CAPITOLA PLANNING COMMISSION

Thursday, September 3, 2020 – 7:00 PM

TO: PLANNING COMMISSION
 FROM: COMMUNITY DEVELOPMENT
 DATE: SEPTEMBER 3, 2020
 SUBJECT: **212 Cherry Avenue #19-0737 APN: 035-161-09**

PROPOSED ELEVATIONS

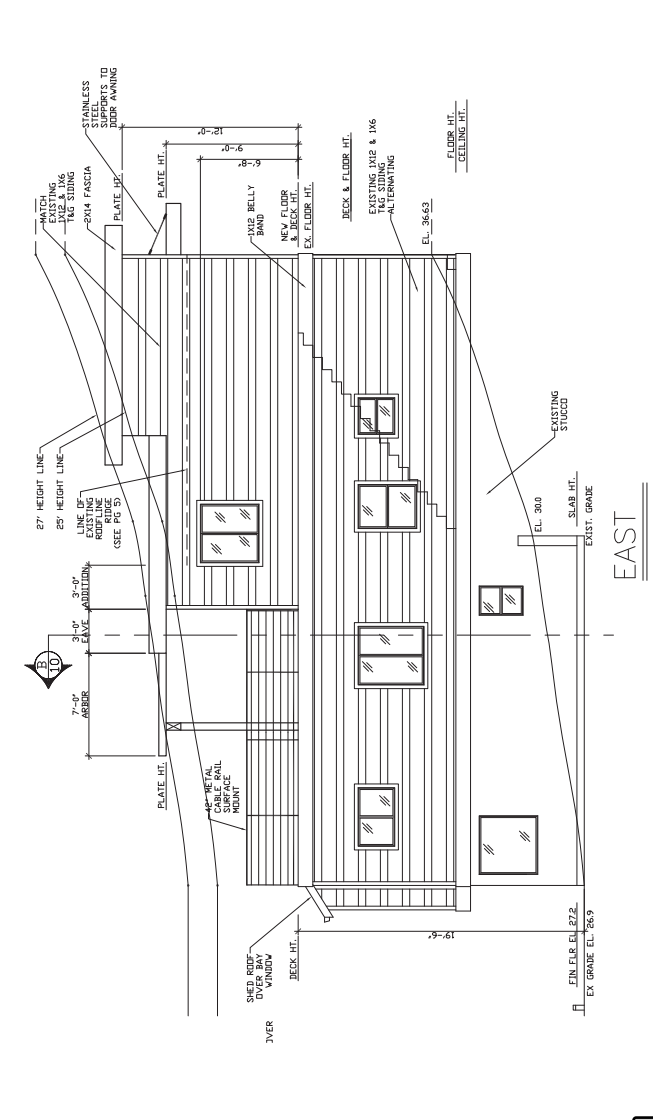
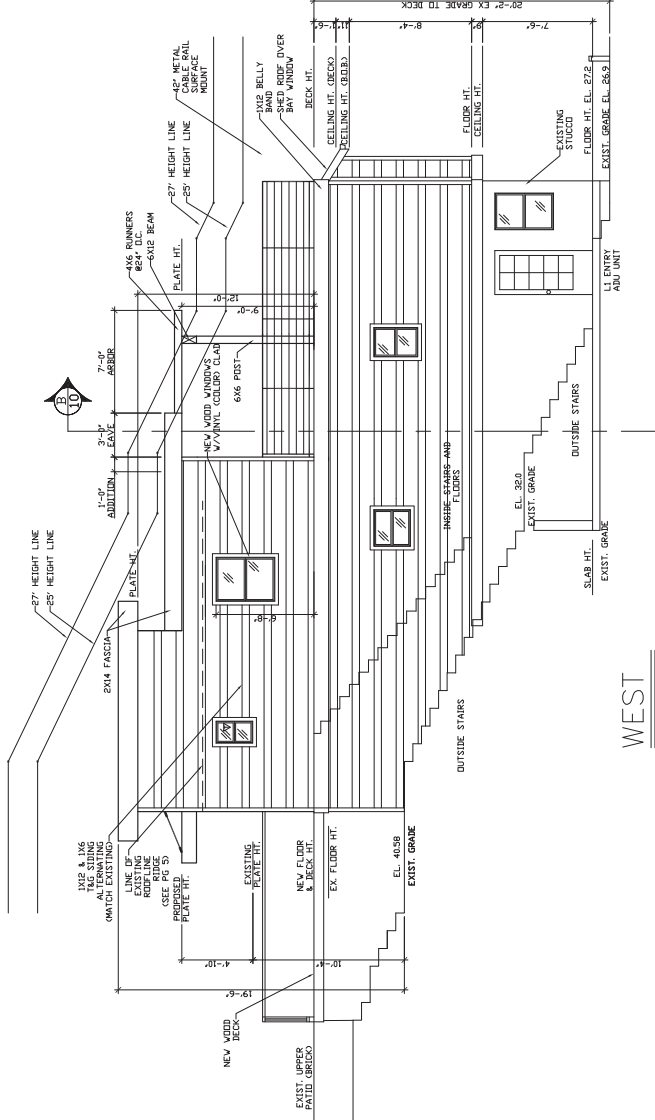
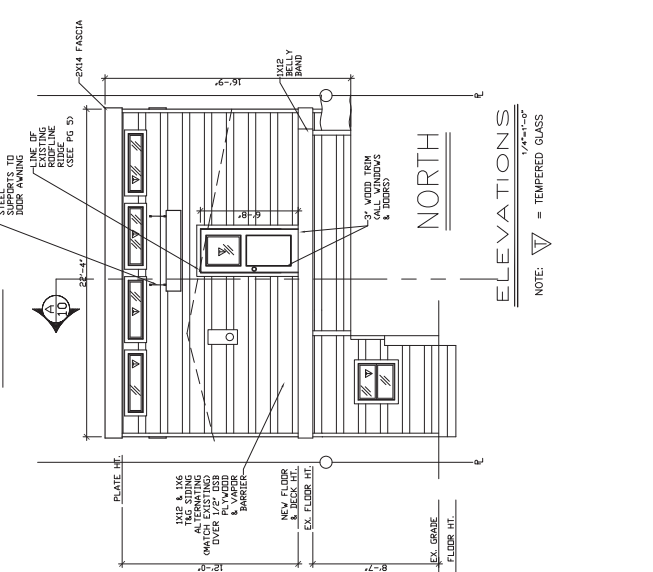
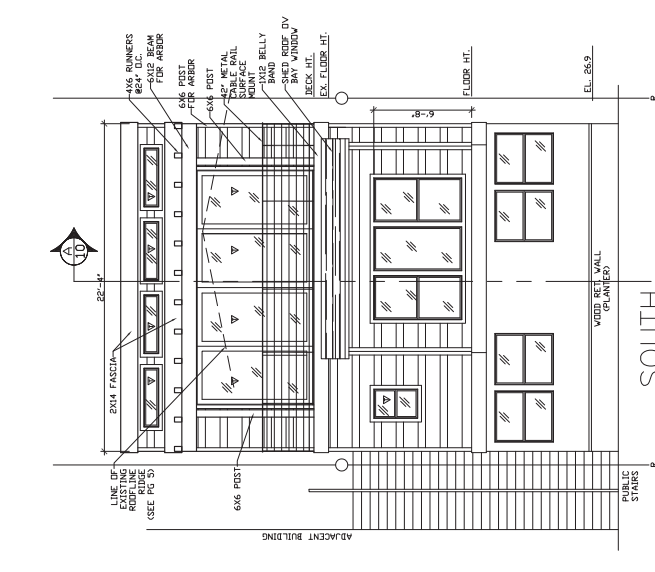
Assistant Planner, Sean Sesanto: informed the applicant that the roof deck may not be extended over the top of the second-story bay window on the south elevation. The plans should be modified to show a reduction of the bay window height and the new guardrail along the south edge of the rooftop deck restricting access to the area.

Following the Architecture and Site Review meeting, the applicant submitted revised plans that reduced the height of the bay window and incorporated a new guardrail along the south edge of the rooftop deck to prevent use of the bay window roof as a deck area.

SITE PLANNING
 DETAILS

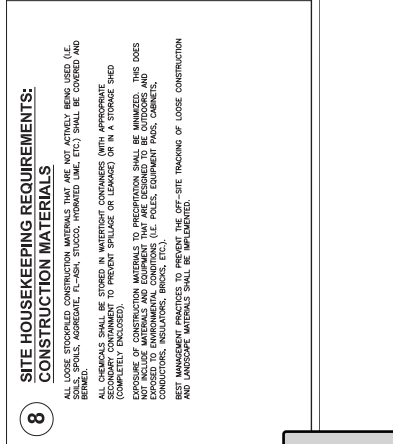
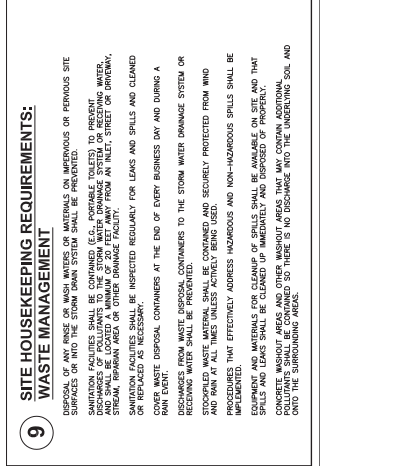
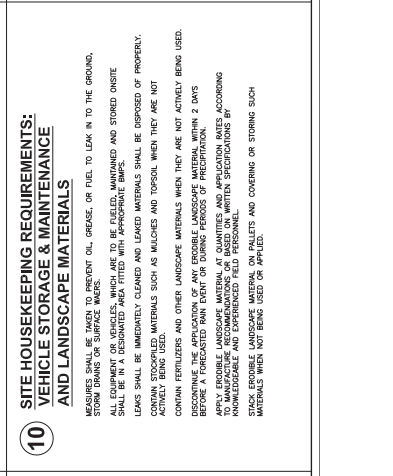
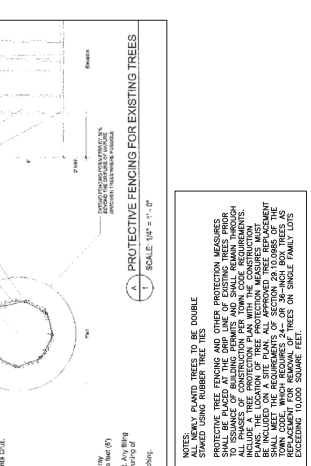
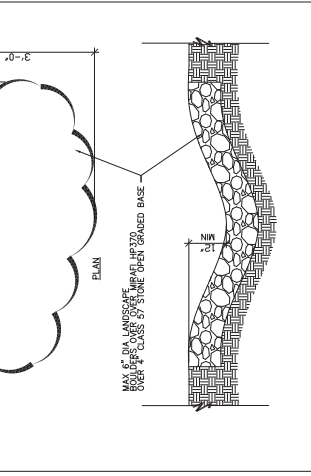
Public Works Representative, Danielle Uharriet: stated that the applicant should provide a detail of the drainage bioswale with the building permit submittal and additional information on detail #6 on sheet 9.

19. Upon receipt of certificate of occupancy, garbage and recycling containers shall be placed out of public view on non-collection days.
20. Prior to issuance of building permits, the applicant shall include a complete detail of the bioswale proposed in the rear yard area planter area.
